ATTACHMENT 1

Marked-up St. Lucie Unit 2 Technical Specification Page

ATTACHMENT 2

This proposed license amendment is intended to revise the Independent Safety Engineering Group (ISEG) reporting and administrative requirements.

Figure 1
Florida Power & Light Company
Nuclear Division Organization

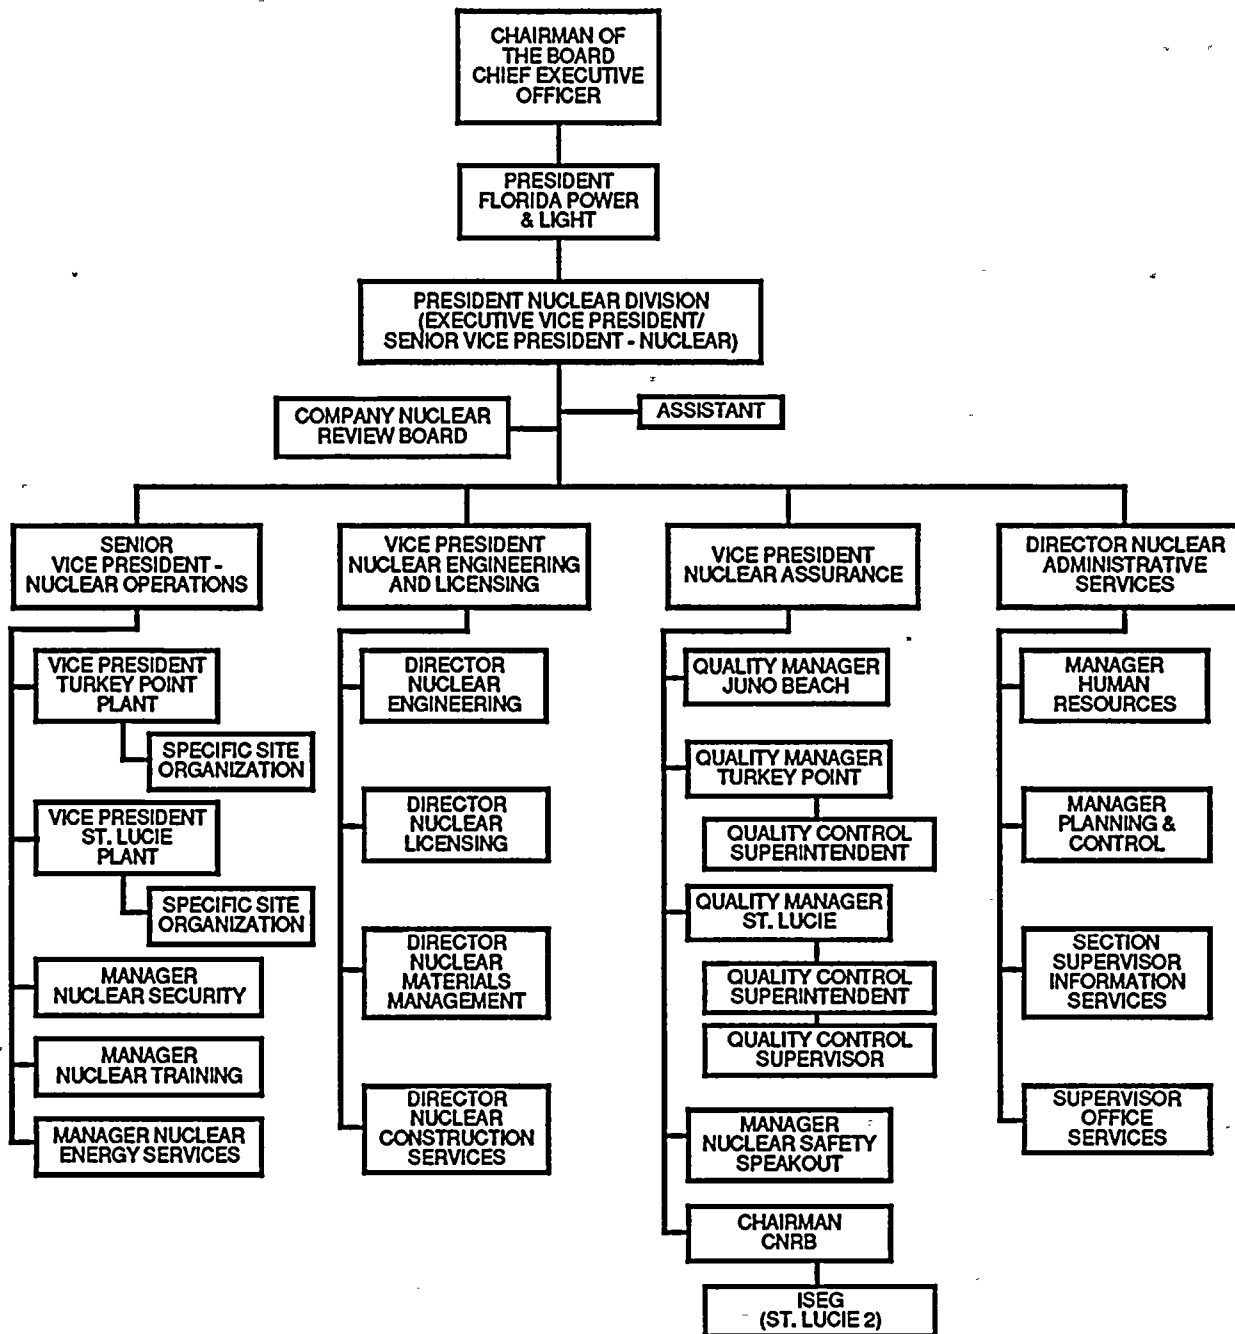
FPL's newly established Nuclear Division maintains control of, and responsibility for, nuclear power plant design, preoperational and start-up testing, operation, maintenance, refueling, and modification of FPL's nuclear power plants in accordance with written and approved procedures. The President, Nuclear Division, has overall responsibility for the Nuclear Division's activities. The organization of FPL's Nuclear Division is presented in Figure 1.

As can be seen in Figure 1, reporting to the President, Nuclear Division, are the Vice President Nuclear Assurance and Company Nuclear Review Board, among others. The Vice President Nuclear Assurance is responsible for the selection, technical direction, administrative control, staffing, training and development of personnel required for supervisory and operating continuity of the Quality Assurance Department, Nuclear Safety Speakout Group and the Chairman, Company Nuclear Review Board (CNRB) (for administrative support only). The Vice President Nuclear Assurance also initiates QA Program policy changes when necessary. In addition, the Vice President Nuclear Assurance is responsible for selecting a team independent of the Quality Assurance Department to perform periodic audits of the Quality Assurance Department. The results of these audits are presented to the Vice President Nuclear Assurance and the CNRB.
